REQUEST FOR COUNCIL ACTION

AGENDA SECTION: PUBLIC HEARINGS	ORIGINATING DEPT: PLANNING	ITEM NO. <i>E-7</i>
ITEM DESCRIPTION: Land Subdivision Permit (Preliminary Plat) #03-24 by Big DE Development to be known as Bandel North Second. The Plat proposes to subdivide 22.91 acres of land into 55 lots for residential development and 1 outlot. The plat also proposes right-of-way dedication for public roadways. The applicant is also requesting approval of a Substantial Land Alteration to permit site grading that will modify grades by more than 10 feet on portions of the property. The property is located east of the Bandel North First Subdivision and north of the Boulder Ridge Second Subdivision and allows for the continuation of Bandel Drive NW.		PREPARED BY: Theresa Fogarty, Planner

RE: Land Subdivision Permit (Preliminary Plat) #03-24 by Big De Development to be known as Bandel North Second. The Plat proposes to subdivide 22.91 acres of land into 55 lots for residential development and 1 outlot. The plat also proposes right-of-way dedication for public roadways. The applicant is also requesting approval of a Substantial Land Alteration to permit site grading that will modify grades by m

BANDEL NORTH SECOND

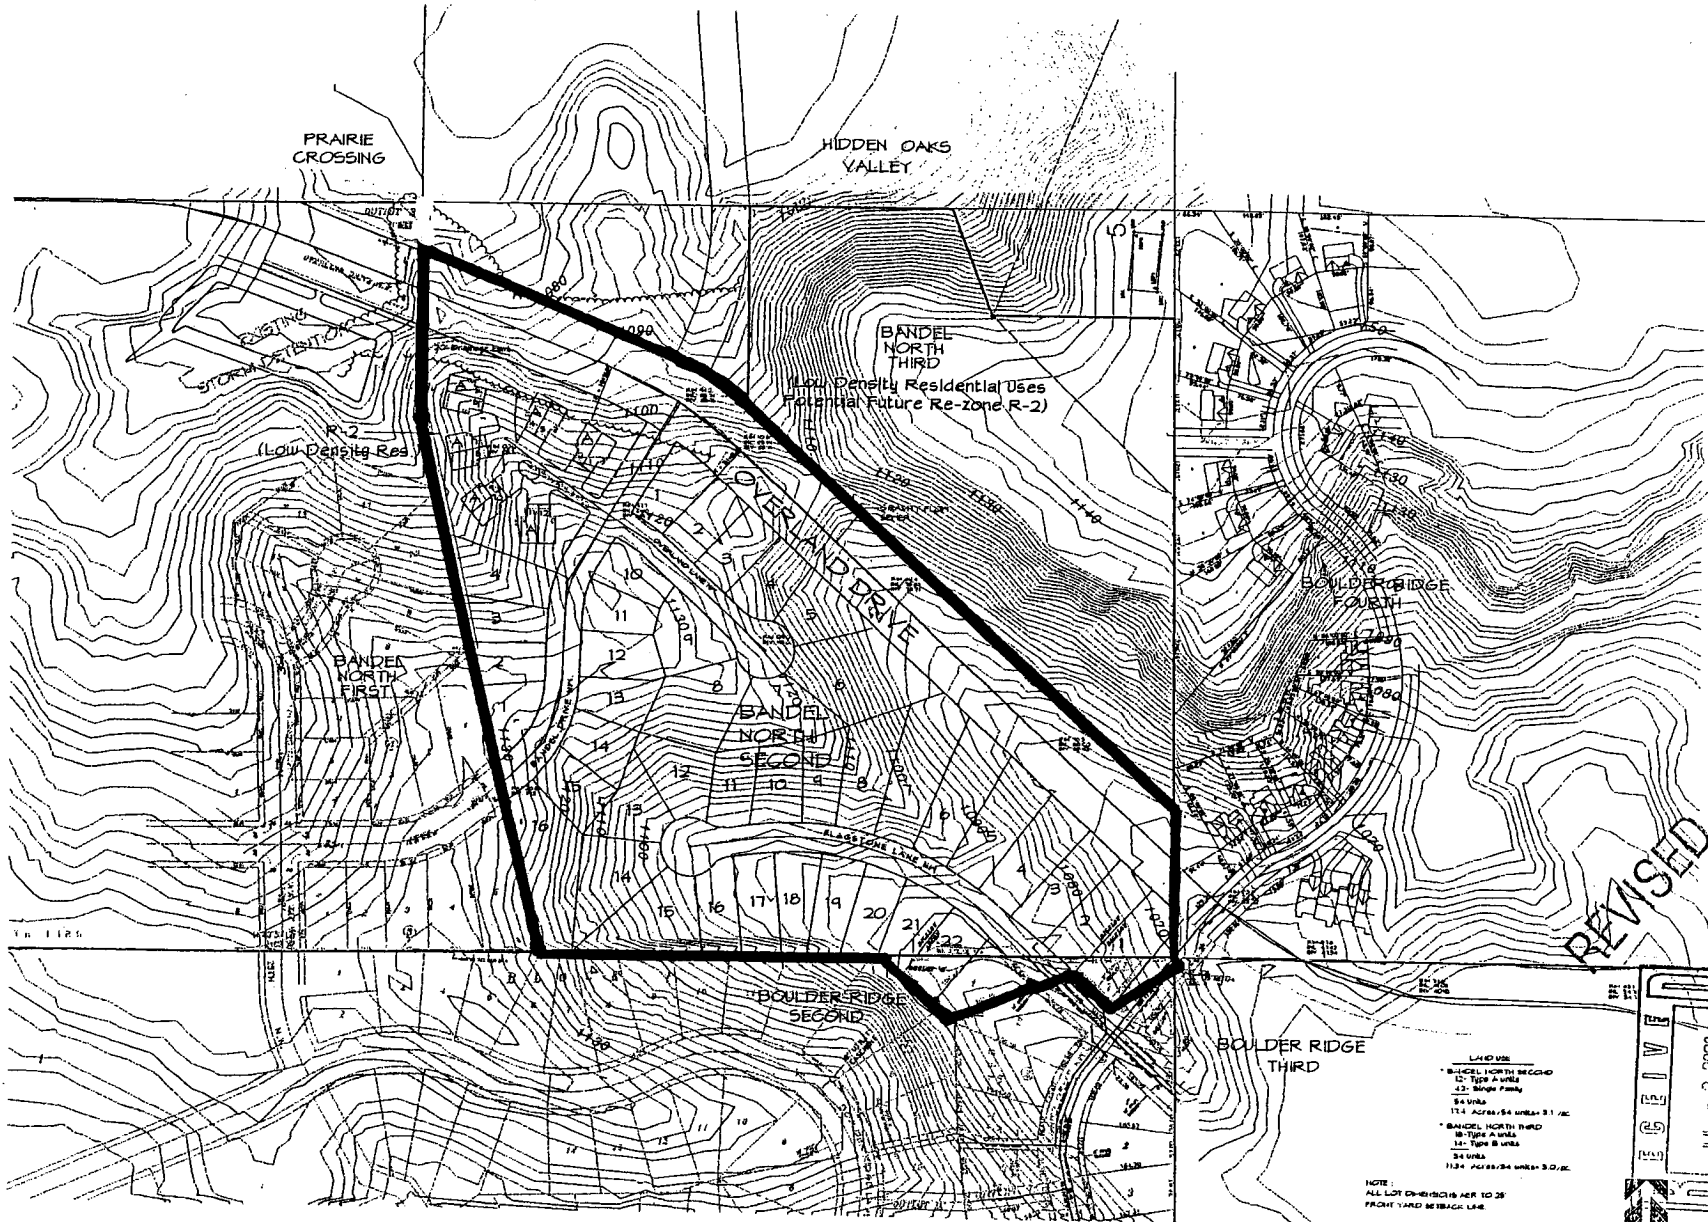
- a. **Outlot "A" the private roadway needs to be given a designation. Coordinate the roadway name with the Planning Department – GIS Division to prevent duplication of a roadway name.**

- b. **Correcting the face of the plat by changing "MOST NO'LY COR" to "MOST SO'LY COR" located in the upper left corner.**
- c. **Dedicating a 30' wide outlot mid-block connection between Lots 11 & 12 and Lots 32 and 33, Block 2. The owner shall be obligated to grade and construct a 10' wide bituminous pedestrian path for the connection, prior to dedication to the City.**

- d. **Dedicating controlled access along the entire frontage of both sides of Overland Drive NW, with the exception of any public road access locations approved through this plat, or the approved GDP for Hidden Oaks to the north of Overland Drive NW and along the entire frontage of Lot 16, Block 1 and Lot 39, Block 2, abutting Bandel Drive NW, and the entire frontage of Lot 1, Block 1, abutting Granite Drive NW.**

3. **Overland Drive NW and Flagstone Lane NW are less than 28 feet in width and shall be posted "No Parking" on one side of these streets. The cul-de-sac located on Flagstone Lane NW is less than 96 feet in diameter and shall be posted "No Parking".**

SUBSTANTIAL LAND ALTERATION

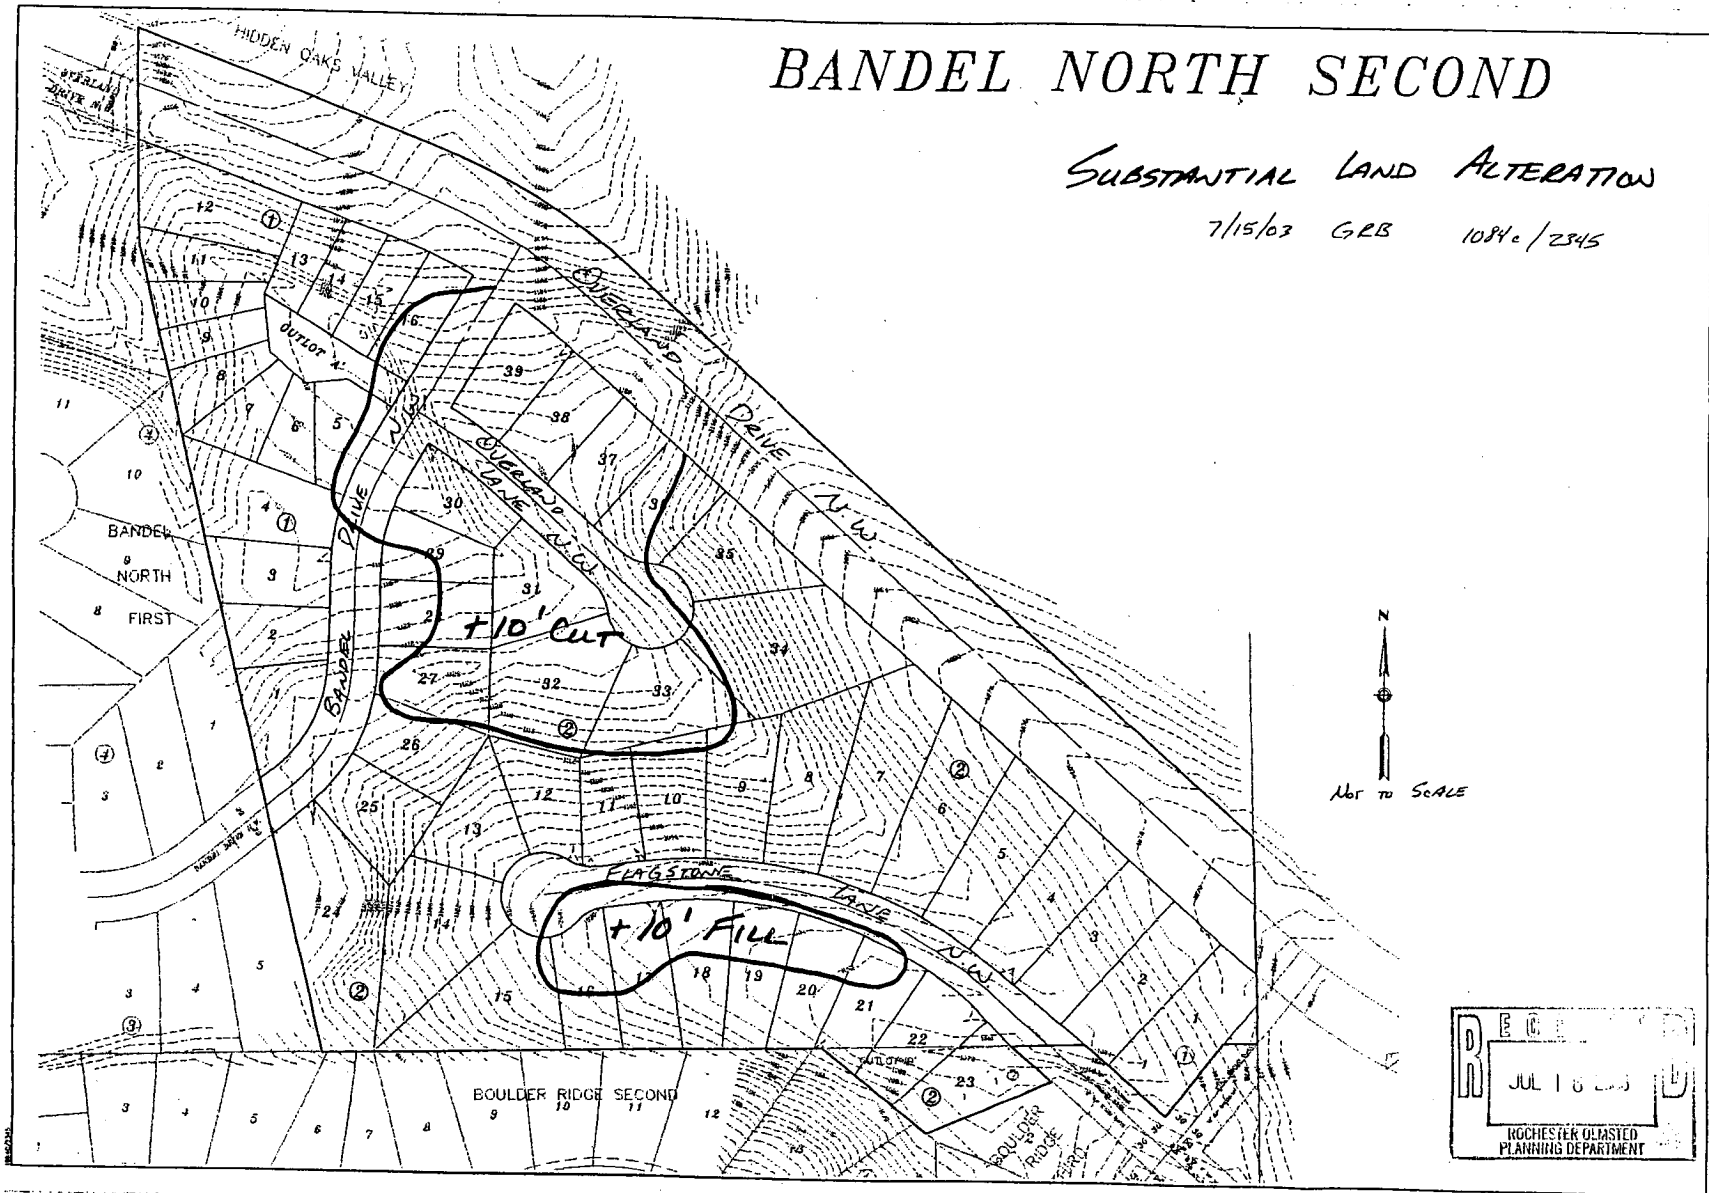
This development includes a proposal for fill work which involves a grade change of 10-feet or more from the pre-existing grades.. The approximate area where the grade is proposed to be changed are, Block 1, Lots 4 & 5, 16 and Block 2, Lots 9 & 10, 26-39 will be cut and Block 2, Lots 15 -21, will be filled. The maximum fill will be approximately 16 feet and the maximum cut will be approximately 20 feet.
